THE THANET EXTENSION OFFSHORE WIND FARM ORDER

Written Representations submitted on behalf of Estuary Services Limited

Unique Reference Number	EN010084
Rule No.	8(1)(a), and 10(1), (2) and (4)
Document Ref.	ESL3
Author	Winckworth Sherwood LLP
Date	15 January 2019

Sea Zones Plan – Reduction in red line boundary

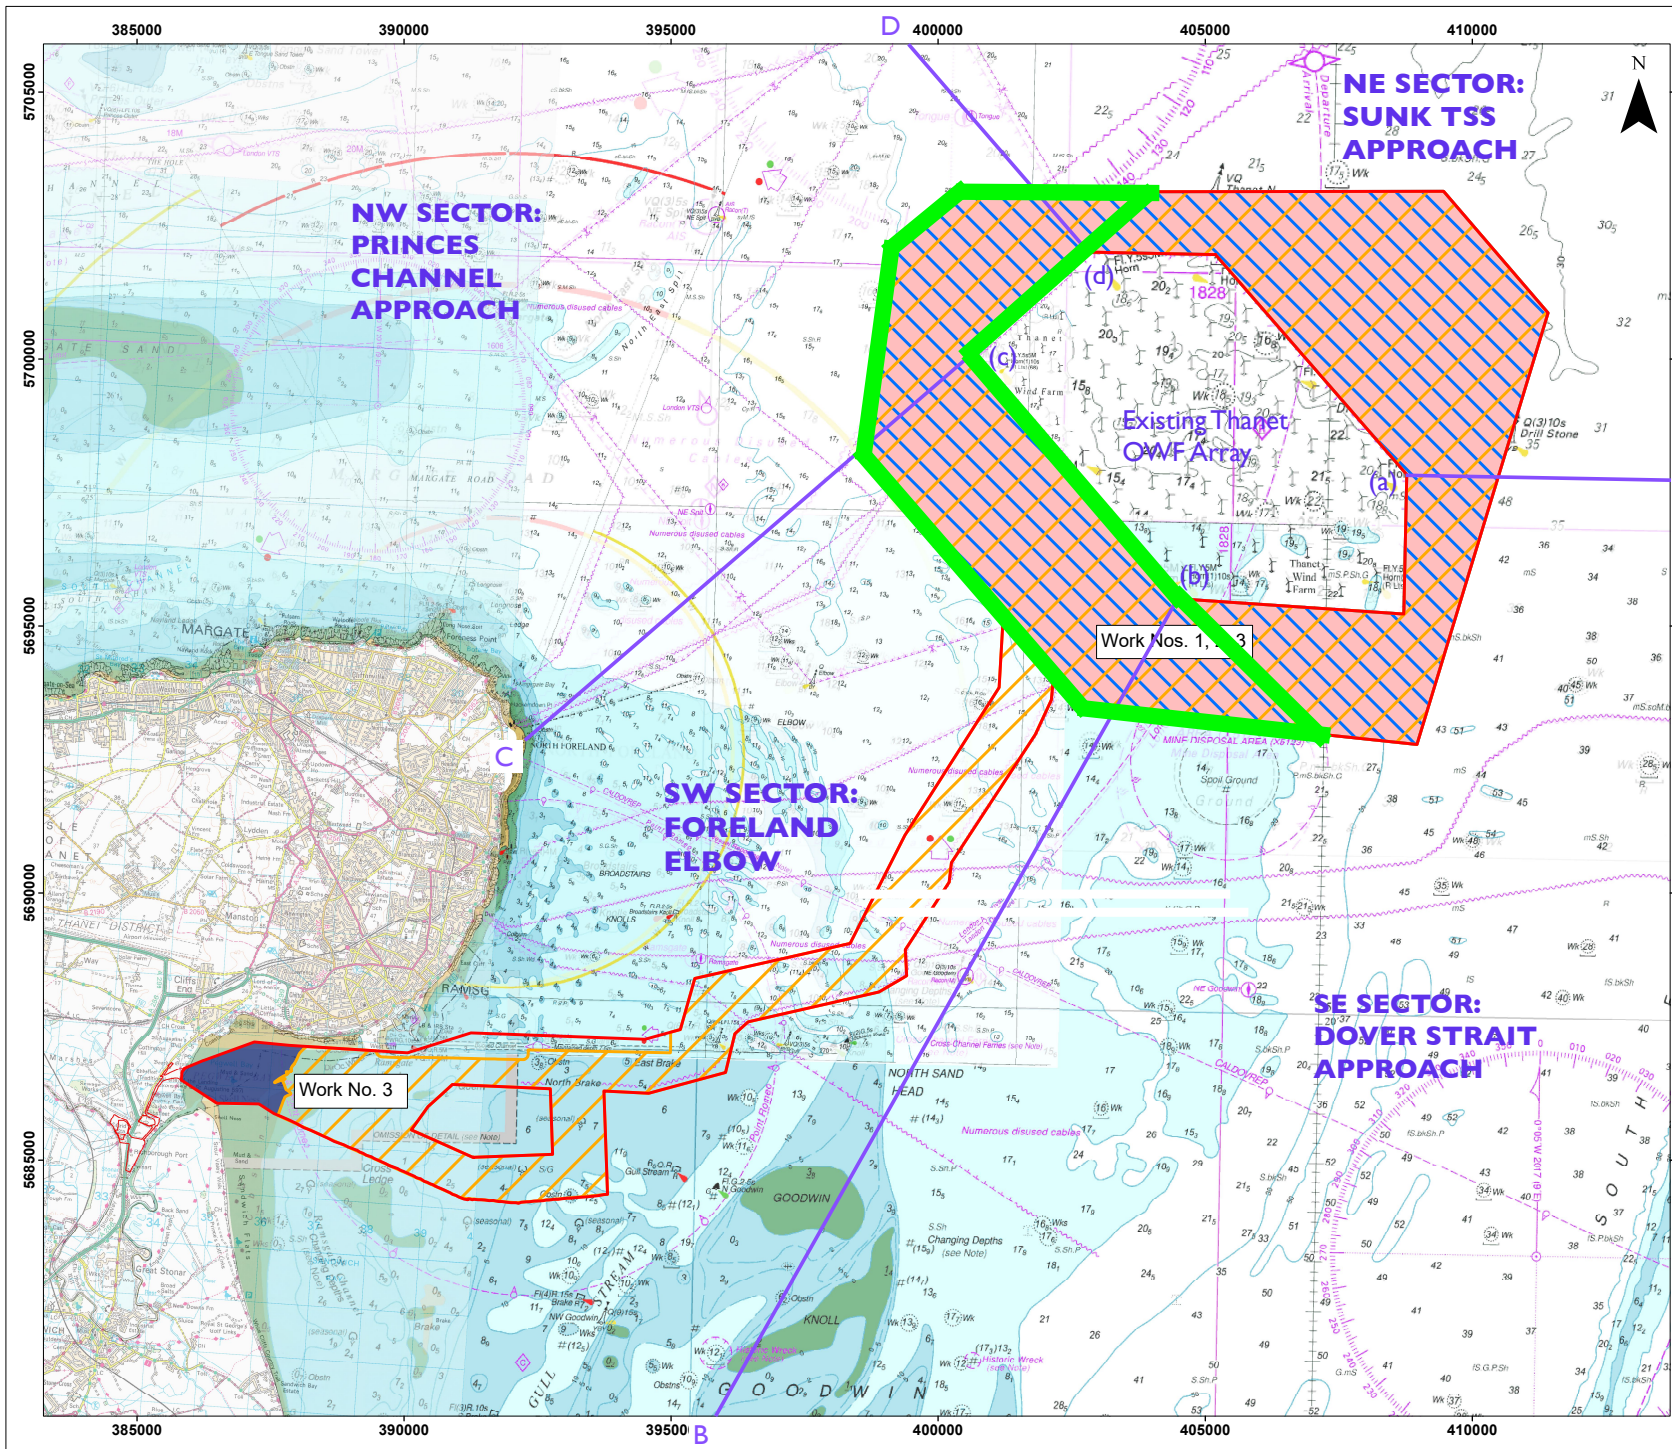
- 7.1 The mitigation desired by ESL is a further reduction in the Red Line Boundary of the application at the Western boundary of the site. Although the Applicant has already proposed a reduction in the Red Line Boundary, it is the position of ESL that this is insufficient to address its concerns about navigational safety. ESL's desired revised Red Line Boundary is illustrated on the Sea Zones plan included with these Written Representations as Appendix 1. This plan illustrates the area of the proposed extension which ESL requests be removed from the DCO edged in green. Reducing the area of the proposed red line boundary to this extent would address the ESL's concerns with the Scheme.

Proposed area for reduction shown edged green.
